ADDENDUM NO. 2
SEWER SYSTEM IMPROVEMENTS
CONTRACT 18-01
WATER TREATMENT PLANT IMPROVEMENTS
LIVINGSTON, TENNESSEE
WAUFORD PROJECT NUMBER 2068
CDBG PROJECT NO. 53789-12021

Date of Addendum: Tuesday, June 12, 2018
Bid Opening: Thursday, June 14, 2018, 2:00 P.M. Central Time

SECTION D-4 - DEMOLITION
SCALE: 1/4" = 1'-0"

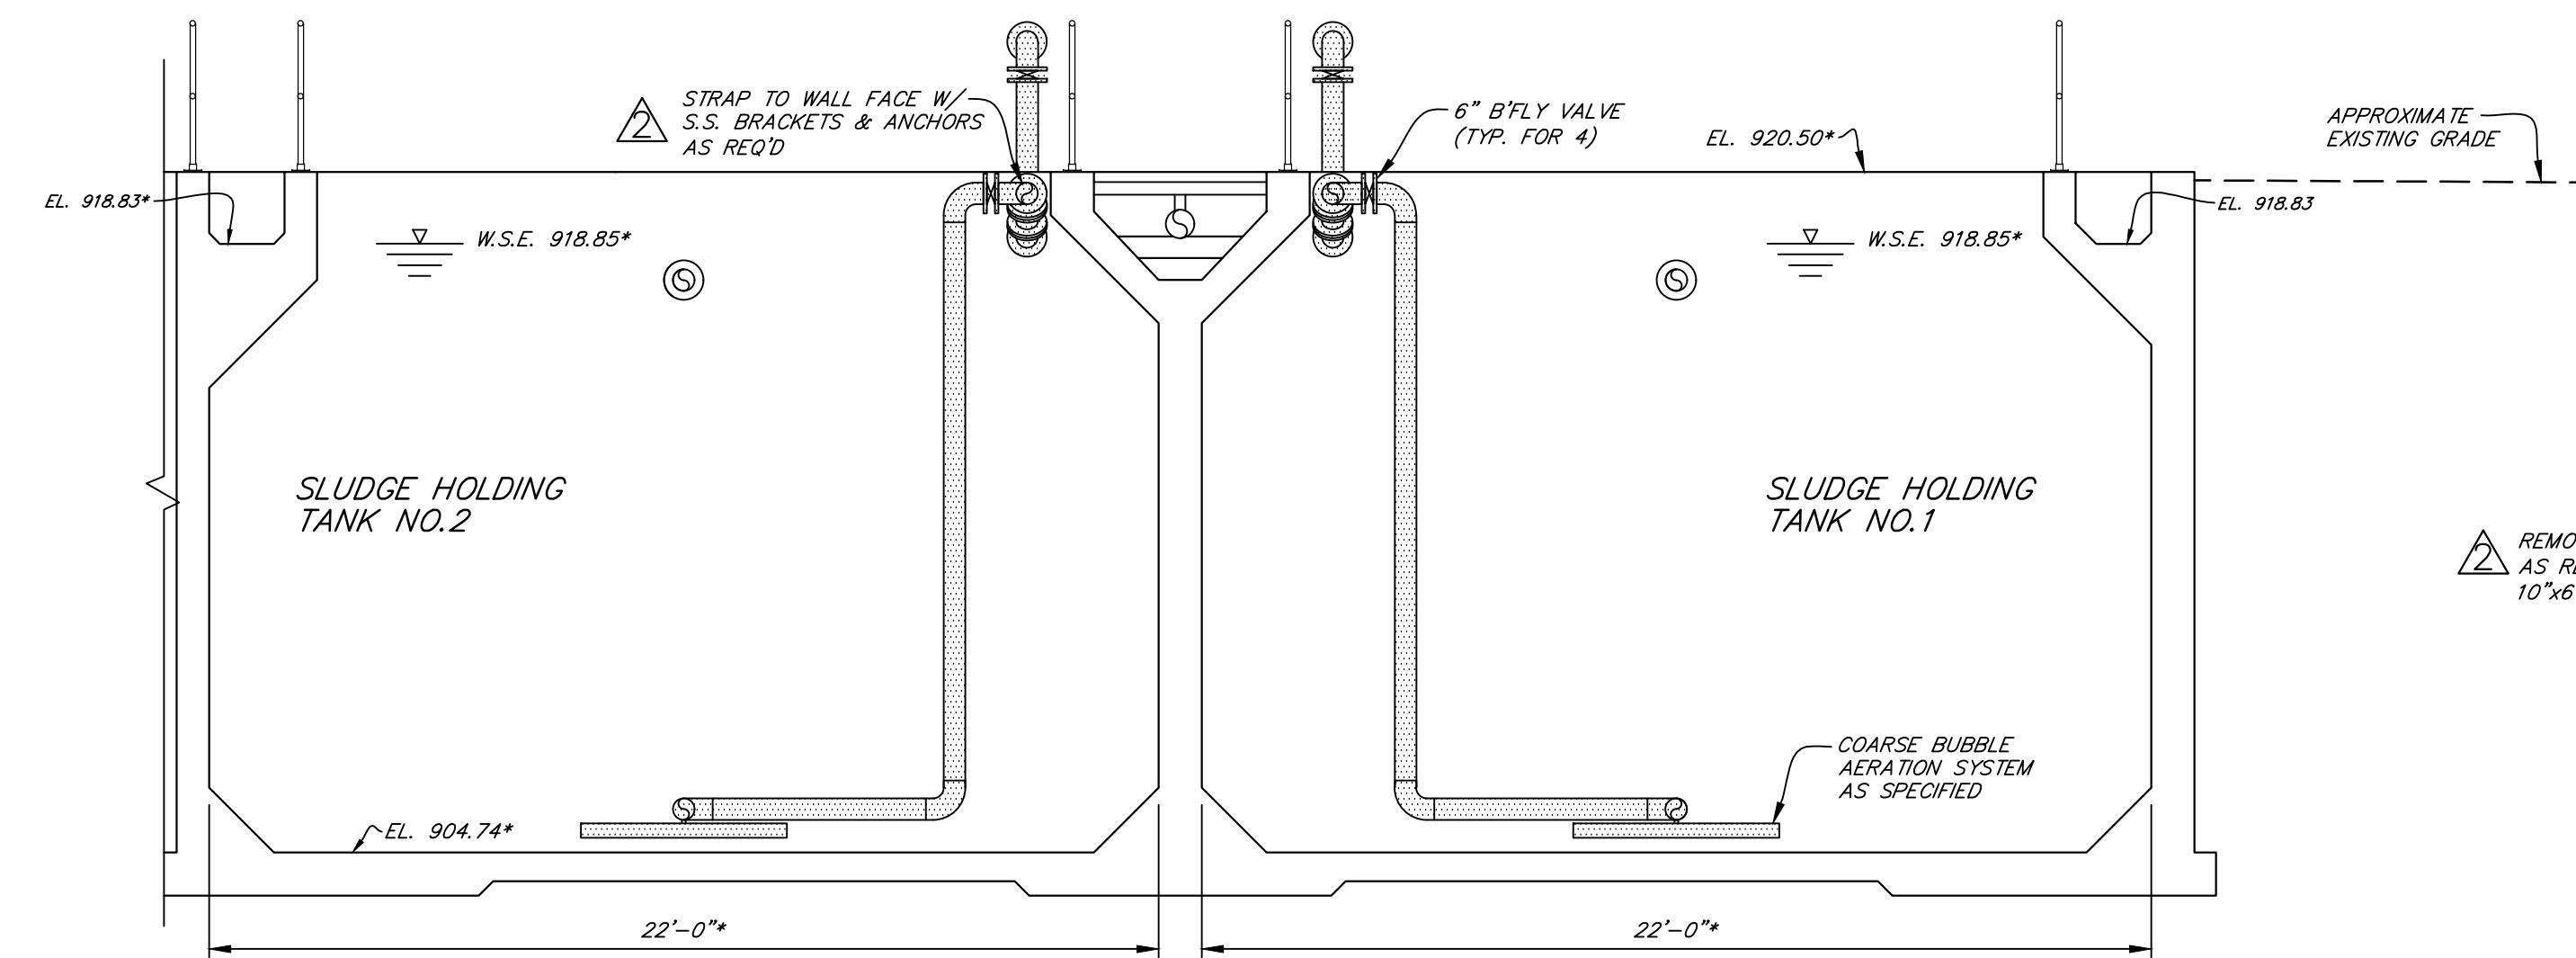
3. Plans, Sheet 4:

Modify as shown on the attached 30" x 42" sheet.
